TECHNICAL MEMORANDUM

To:	City of Joondalup	From:	Gil Alexander
Attention:	Richard Greening	Date:	6 September,2022
Email:	Richard.Greening@joondalup.wa.gov.au	JDSi Ref:	JDS222126.02
CC:	Matthew.MacPherson@joondalup.wa.gov.au	Pages:	4 plus attachments
Subject:	Lane 5 Clontarf Street, Sorrento

LANE 5, CLONTARF STREET, SORRENTO

FIGURE 1 Microfine Cement Injection

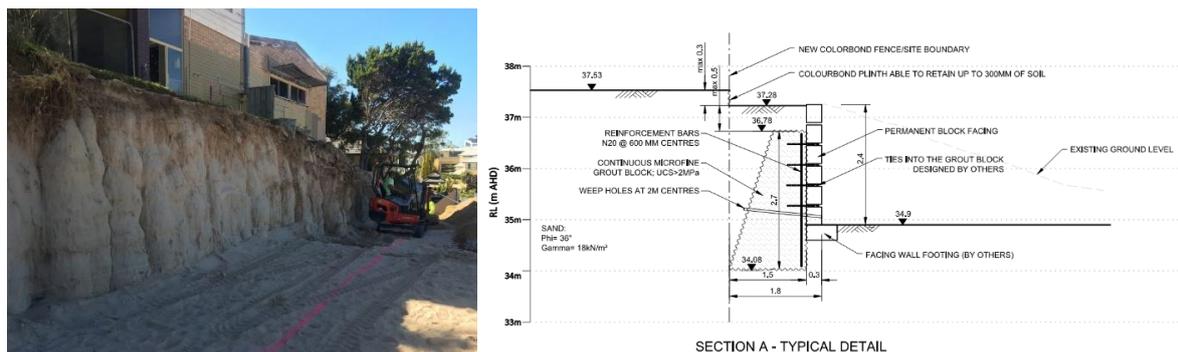
As can be seen from **Figure 1 Microfine Cement Injection**, approximately 1.8m width on each side of the Lane 5 would be required to accommodate a 2.4m high retaining wall. Consequently, the adjoining owners of lots 403 and 402 would need to agree to microfine cement injection extending into their property boundary, so that the permanent block face could be moved back towards the lot boundary to achieve the required 4.4m pavement width with adequate clearances from the retaining wall.

JDSi recommends the adoption of the microfine cement injection with block facing as the most likely option being the best cost and time effective approach.
